REGIONAL REVIEW NOTIFICATION

ARC REVIEW CODE: R2008071

Name of Proposal: GT Technology Enterprise Park (DRI #3131)

GT TECHNOLOGY ENTERPRISE PARK DRI
City of Atlanta
Natural Resources Group Review Comments

TITLE
DRI SITE PLAN

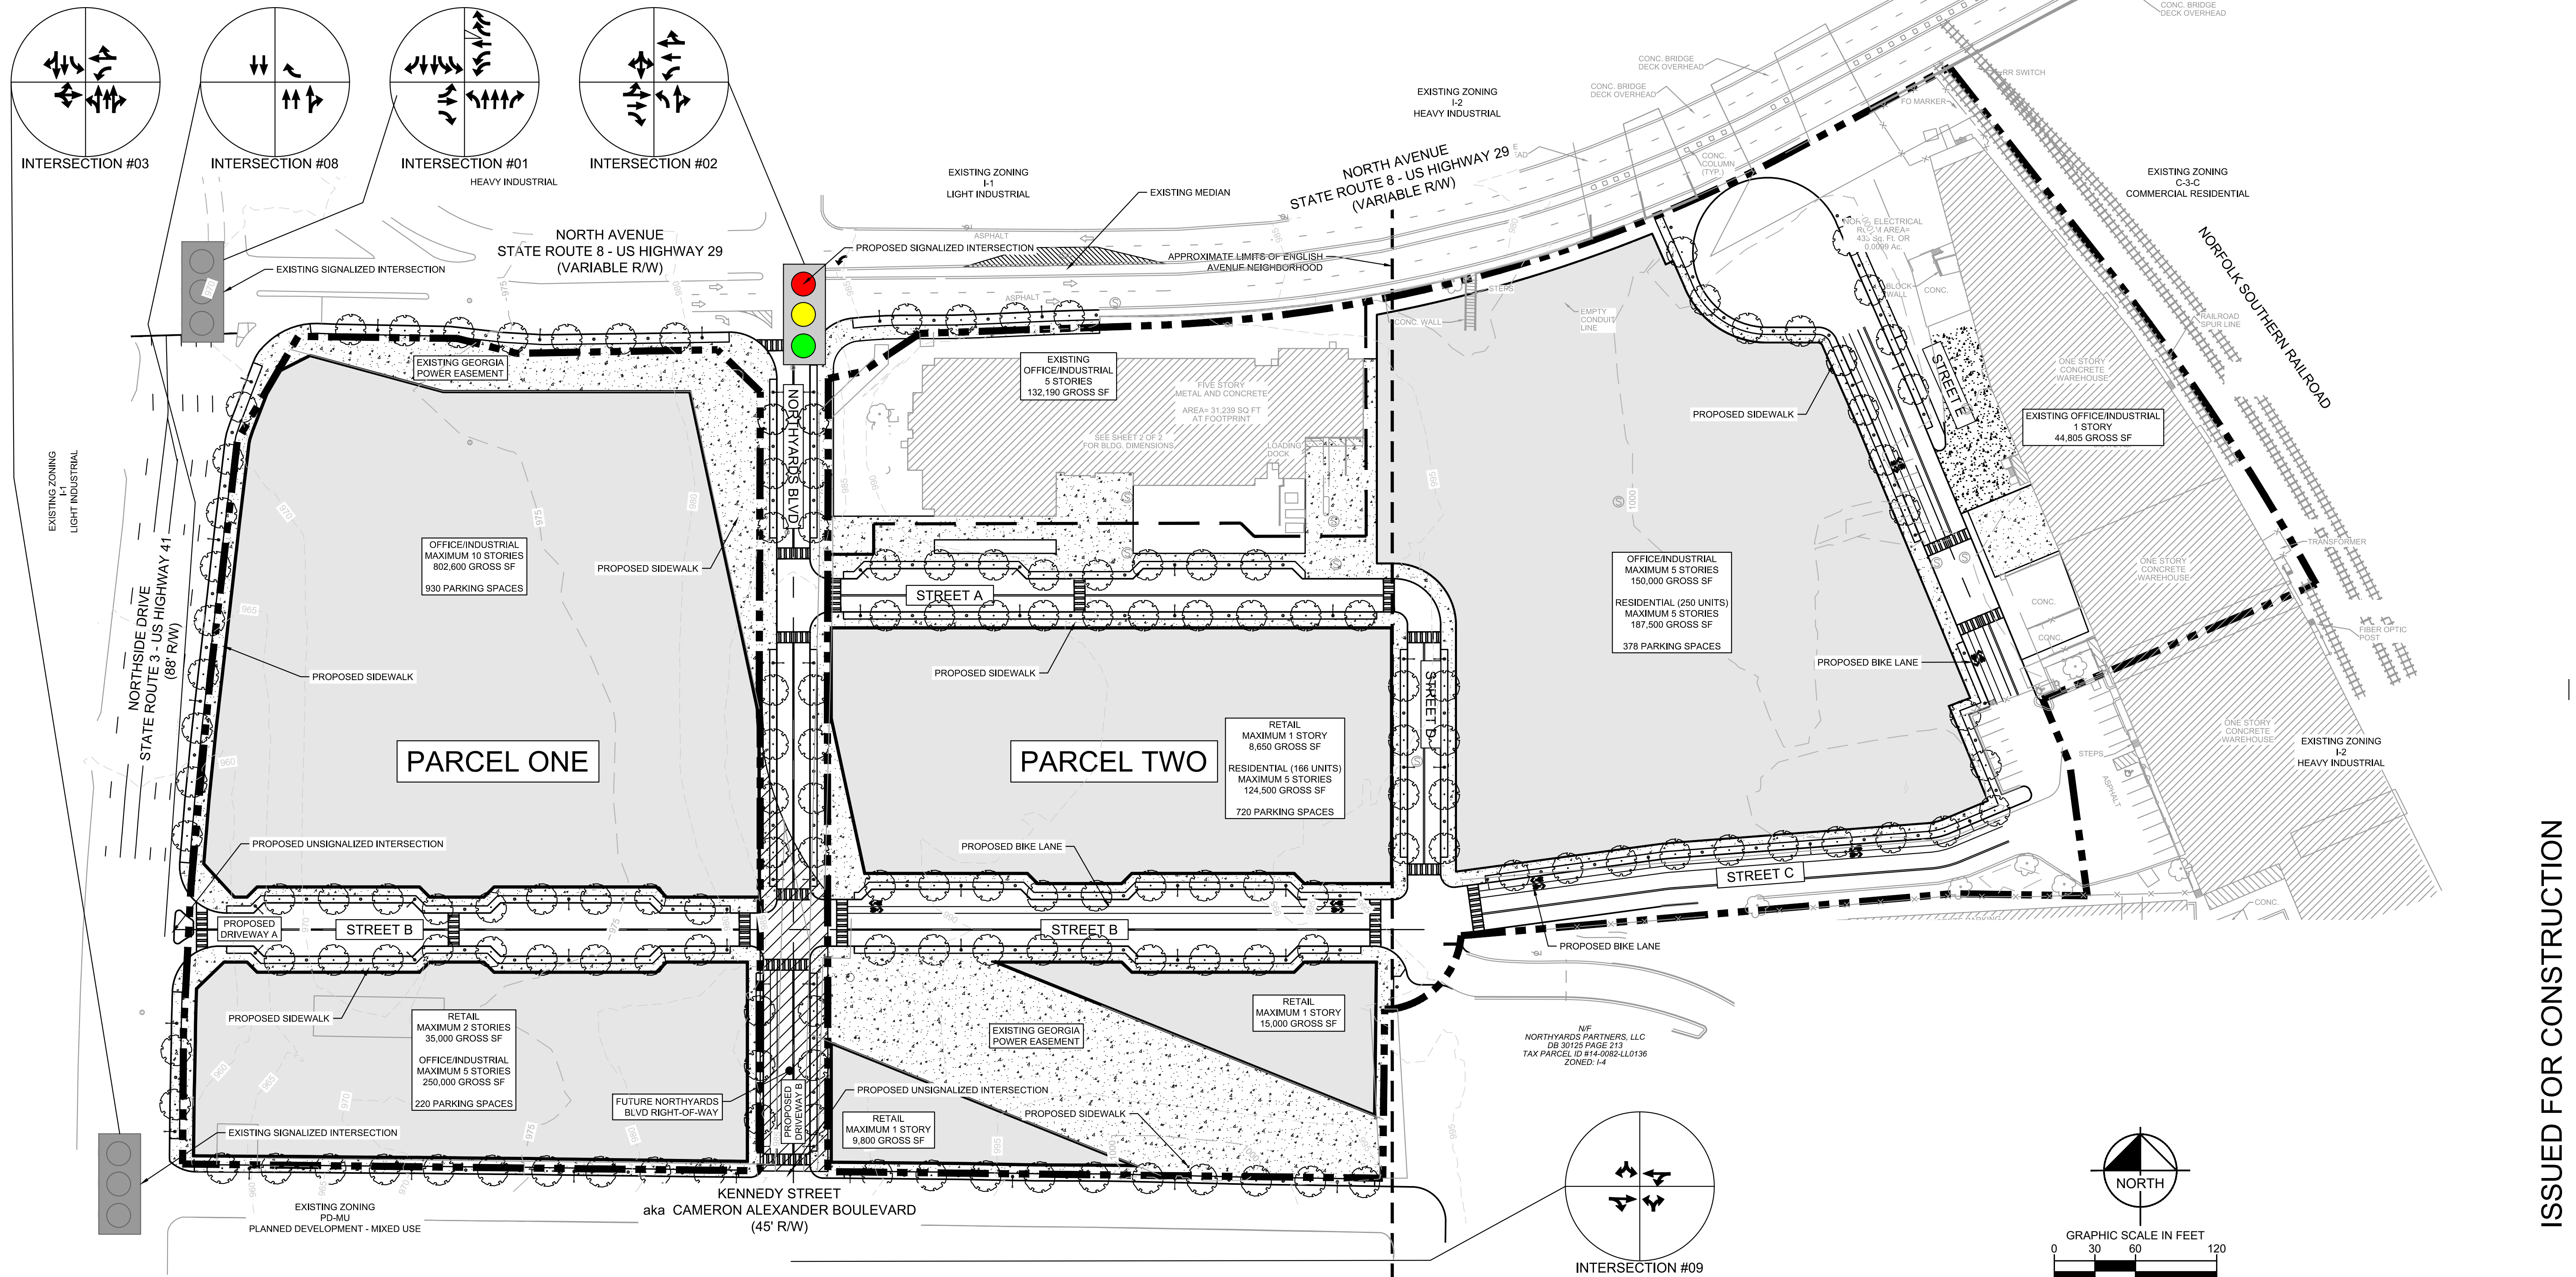
As of this writing, the submitted site plan only depicts building "envelopes," with basic uses, density, and number of parking spaces on each parcel within the development. Pedestrian and vehicle entrances are not indicated, which makes it difficult to understand internal site circulation. It does not indicate locations of transit and ride-hailing services in relation to the various uses. Bike facilities are shown on some of the internal streets, but it's not clear whether there is a larger plan to facilitate alternative modes. The two-way cycletrack depicted on Streets B, C, and E is not an accepted roadway configuration for bike facilities by most standards, unless it is protected with no parking on the side. It would be preferable to implement aggressive traffic calming with shared space on all interior streets rather than a mix of shared streets and separated facilities. Attention to alternative modes is all the more important considering the likely tenant mix for all uses will include students, many of whom don't own or use personal automobiles. Bike racks and spaces for shared mobility options, such as bike-share and scooters, should be clearly identified and logically placed throughout the site.

Traffic analysis states that between 1000 – 1500 parking spaces provided while site plan shows over 2000.
